South Texas Project  
Units 1 and 2  
Docket Nos. STN 50-498 and STN 50-499  
Additional Information Regarding Sensitivity Studies for  
STPNOC Risk-Informed Pilot GSI-191 Application  
(TAC NOS. MF2400 – MF2409)

**Additional Information Regarding Sensitivity Studies for  
STPNOC Risk-Informed Pilot GSI-191 Application**

## **SNPB-3-20 Supplemental Information**

Figure 1. PCT (Reference Case B1; Sensitivity Case B1F)

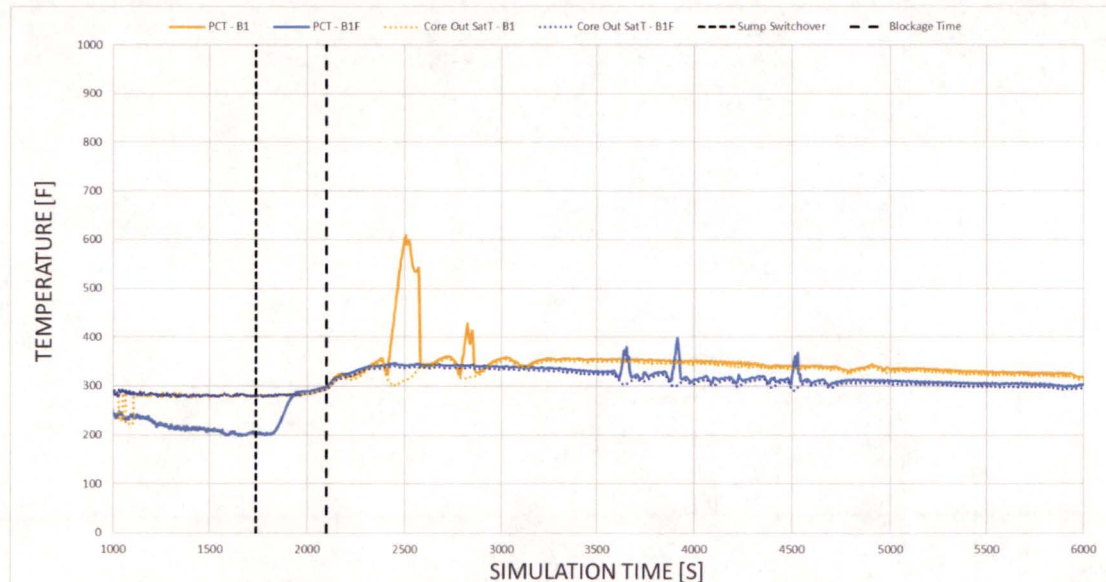
*The staff understood that the bypass sensitivity study would assume a true single worst failure. The staff does not believe the single failure of the ECCS train is the worst failure. Also, the staff believes a top-peaked power shape is necessary and appropriate for this analysis. STP's use of Appendix K decay heat, steam generator tube plugging, and RWST size and temperatures, and sump temperature assumptions appear appropriate.*

An additional sensitivity analysis is conducted to investigate the effect of the power shape on the PCT under the condition of core barrel/baffle bypass open during the post-core blockage LTCC. The sensitivity is executed under the same assumptions and conditions applied to the sensitivity B1 described in the answer to SNPB-3-20. The input file is generated from the one used to perform the simulation B1, only changing the core BB bypass (junction 84501) to be open during the post-core blockage LTCC. As describes in the answer to RAI-SNPB-3-3, this configuration is likely to be the most realistic condition.

No appreciable differences in PCT during the post-core blockage LTCC are found, as shown in Figure 1. Saturation temperature is also included in the figure.

The PCT of the sensitivity case appears smoother than the one simulated under the reference conditions (core bypass blocked).
